# UNITED STATES PATENT AND TRADEMARK OFFICE

APPLICATION NO.	FILING DATE	FIRST NAMED INVENTOR	ATTORNEY DOCKET NO.	CONFIRMATION NO.
10/734,322	12/12/2003	Charles F. Harris JR.	HARRIS-2	1379
7590 12/30/2009				
Huntley, L.L.C. Donald W. Huntley 1105 N. Market Street P.O. Box 948 Wilmington, DE 19899-0948				
EXAMINER				
LAVINDER, JACK W				
ART UNIT		PAPER NUMBER		
3677				
MAIL DATE		DELIVERY MODE		
12/30/2009		PAPER

### Office Action Summary

**DETAILED ACTION**

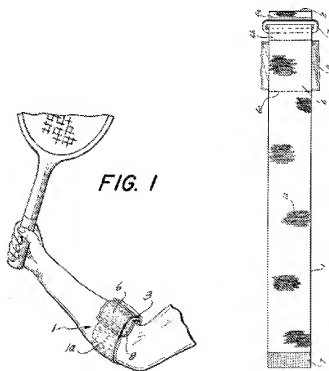
Claims 36, 39, 40, 46, 48, and 51-55 have been rejected under 35 U.S.C. 102(b) as being anticipated by Johnson, Jr., 4628918.

Regarding claims 36, 39, 40, 46, 48, and 51-55, Johnson, Jr. discloses a method for dampening vibration of soft tissue of a human wearer's body part comprising providing a stretchable strap with a step member with a first and second wing and wrapping the strap, under tension, around the body part.
